Access Compliance Report Public Rights-of-Way (Pedestrian Signals)

Main Street: **IRVINE_BLVD** Cross Street: **BROWNING_AVE** Location: **NW**

ADA ID: **SGRK211006111544** Signal Type: **One Push Button-APS** Overall Compliance: **No** Severity Scores: **BTN 1: 25** **BTN 2: N/A** **No BTN: N/A**

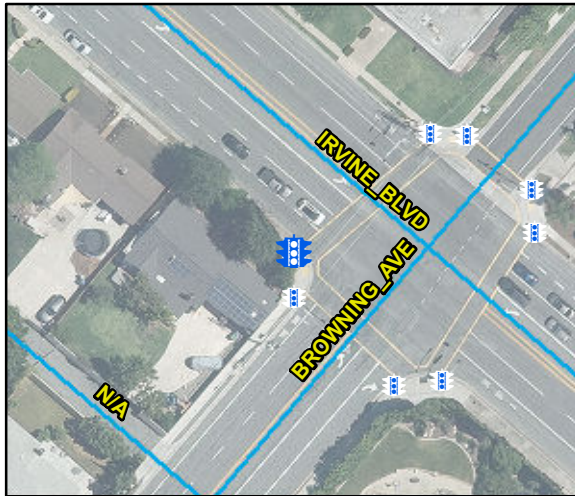
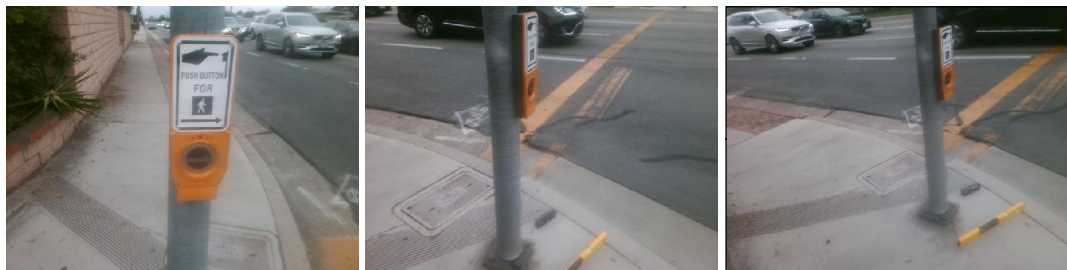
OC Std/PROW: **R404.2**

Possible Solutions: Remove and Replace Clear Space.
